STANDARD DEPARTURE CHART-INSTRUMENT

RJFN / NYUTABARU

INSTRUMENT APPROACH CHART

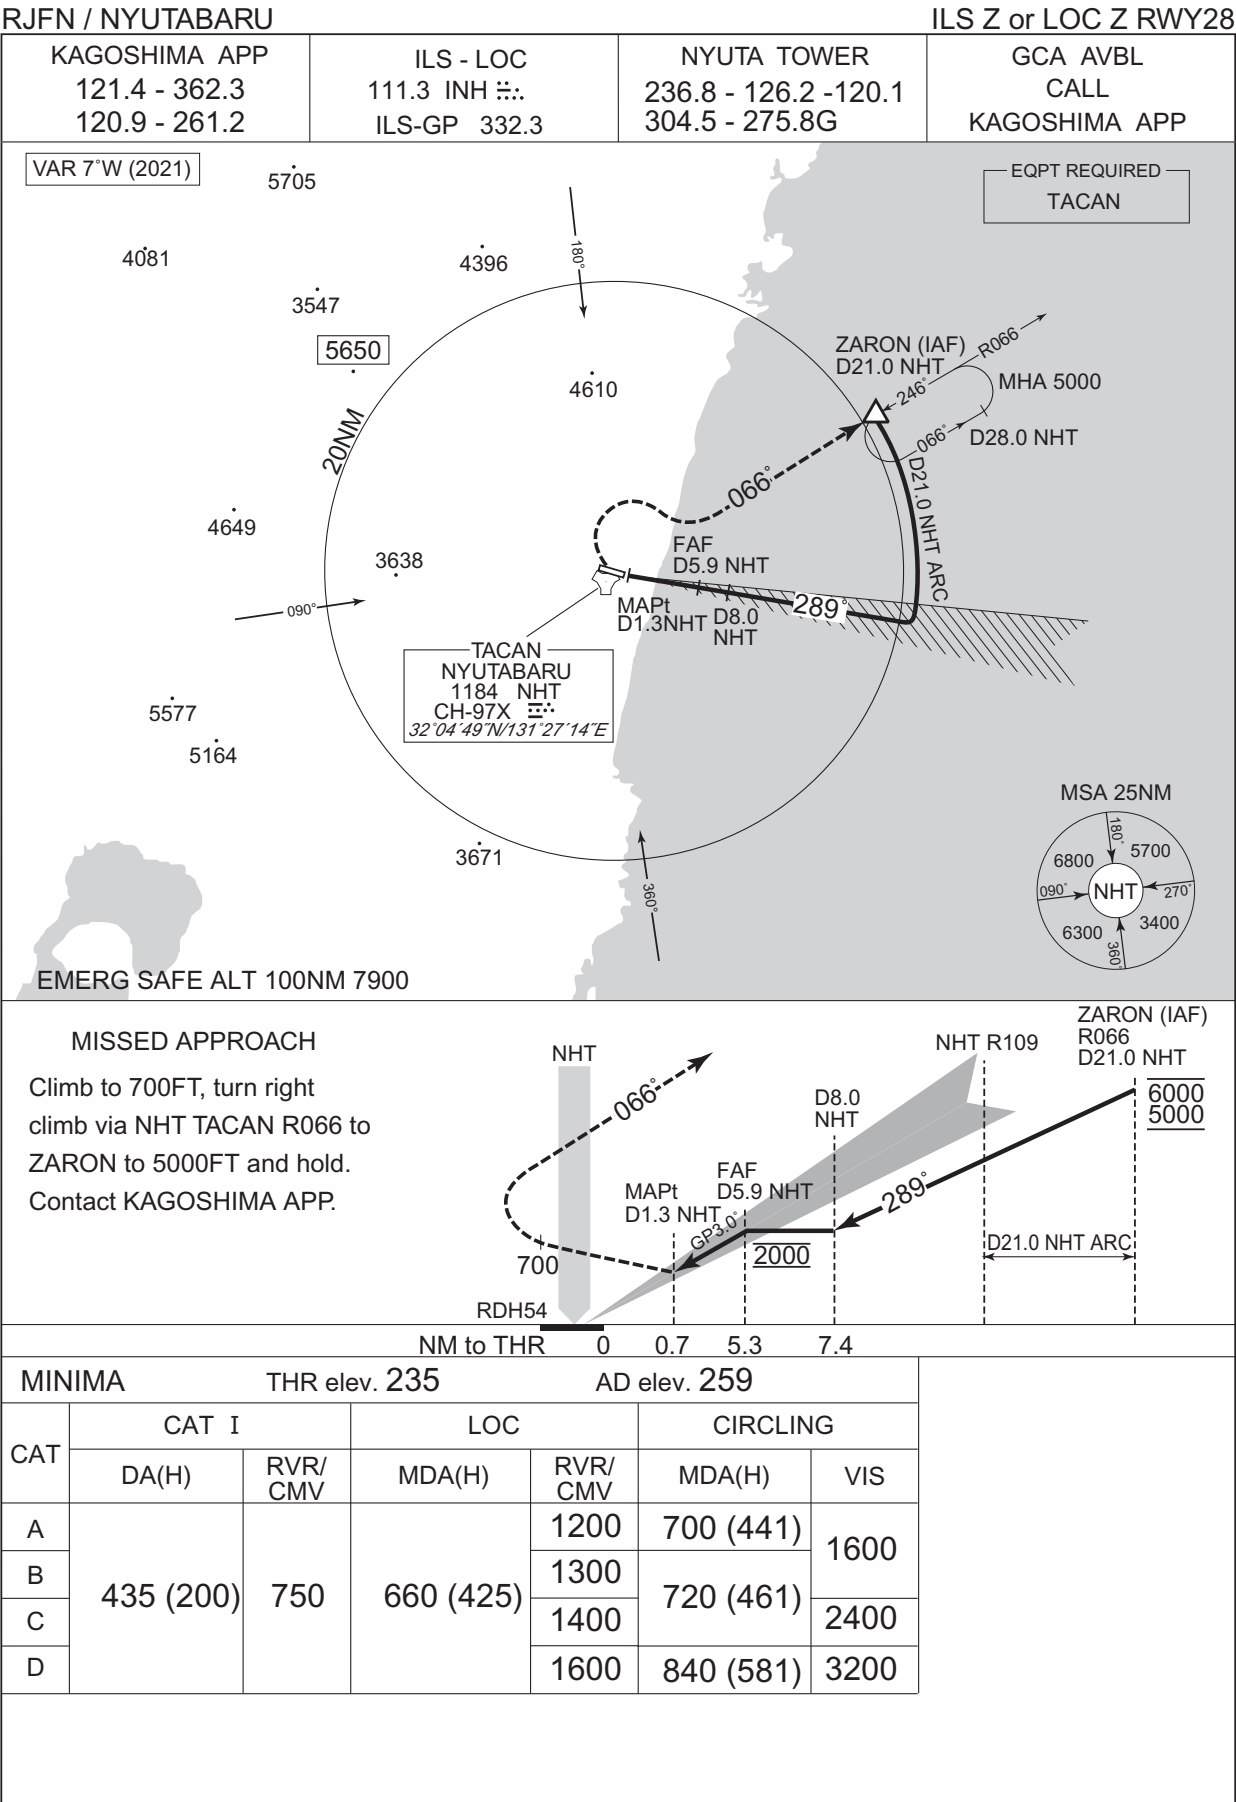
CHANGE : VAR. PROC renamed. EQPT REQUIRED added. PROC course. MISSED APPROACH course. MSA.
NM to THR added. MDA(H) for CIRCLING.

INSTRUMENT APPROACH CHART

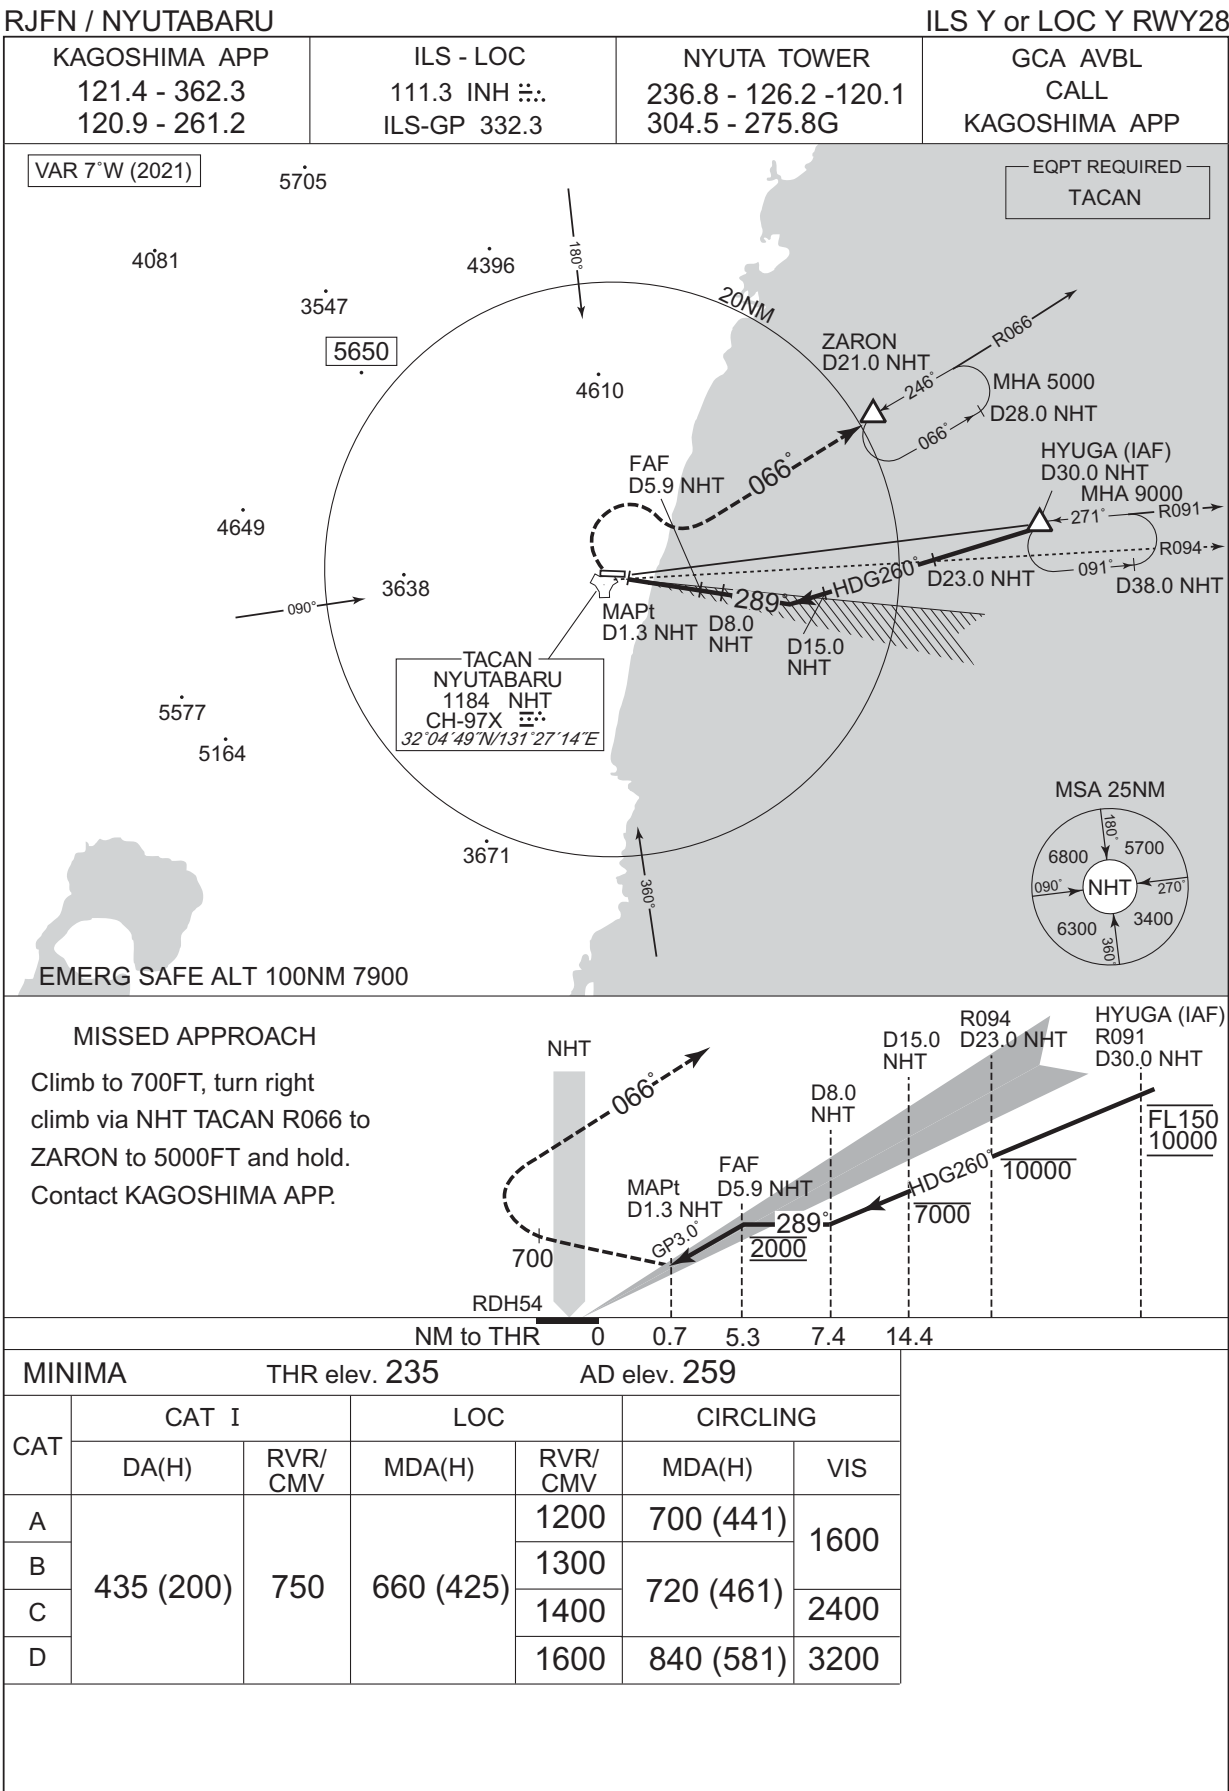
CHANGE : VAR. PROC renamed. EQPT REQUIRED added. PROC course. MISSED APPROACH course. MSA.
NM to THR added. MDA(H) for CIRCLING.
